Weir Phillips Heritage

Re: Amended Concept Proposal for Cockle Bay Wharf (SSD 7684), 17-27 Wheat Road, Sydney – Heritage Response

Figure 2: A concept design by Aspect Studio showing how the pedestrian bridge link will connect to the Pyrmont Bridge.

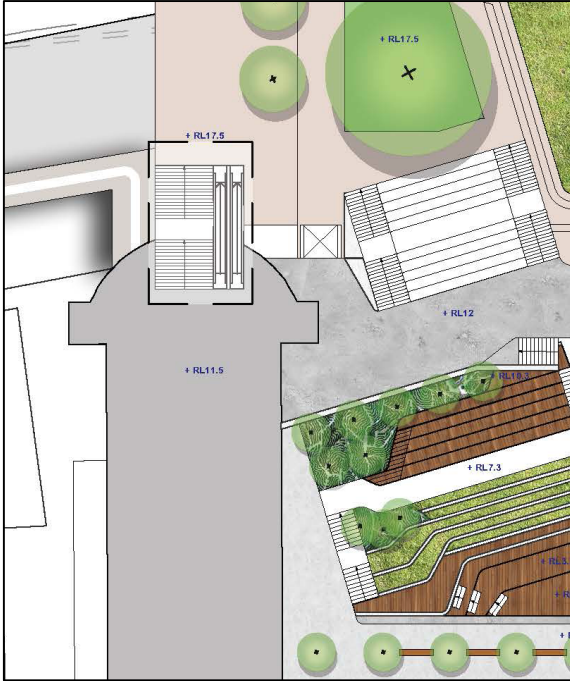
The proposed connection from the amended terraced public landscape to Pyrmont Bridge had been amended. It now connects to the east bridge abutment added in the 1990s and is potentially acceptable. However, the submission mainly uses photo montages and sketch plans to describe this work. Some of these images appear to indicate that the new bridge will cut much closer to the historic Corn Exchange building than existing bridges. This would not be acceptable. In particular, the detailing of the north edge/road portal of the proposed land bridge requires careful detailing as it will be seen as a road portal along the axis of Market Street from the east. The alignment, design and detail of the Market Street land bridge link to Pyrmont Bridge must be resolved to enhance the setting of the Corn Exchange and ensure a high quality and resolved design of the north edge of the new bridge. The detailed design of the connection to of Pyrmont Bridge must be resolved with the input of heritage architects and articulated in the heritage impact statement.

The proposed interface with the pedestrian link and the Pyrmont Bridge will utilise the existing modern fabric connections to the bridge, see **Figure 2** below. The connection will utilise the existing pedestrian link on the far eastern point of the bridge and connect to the lower terrace via staircases and escalators. This option provides an axial connection with Market Street as well as a wider and improved egress for event mode and day to day operation.

This option also allows for the removal of the existing side pedestrian access to Pyrmont Bridge, this will have a positive heritage impact as the profile of the southern elevation will be visible in full. The alignment, design and detail of the Market Street land bridge link to Pyrmont Bridge will be resolved to enhance the setting of the Corn Exchange in the detailed design phase. The Design Architect will consult with Council's Heritage Officers during the design development phase.
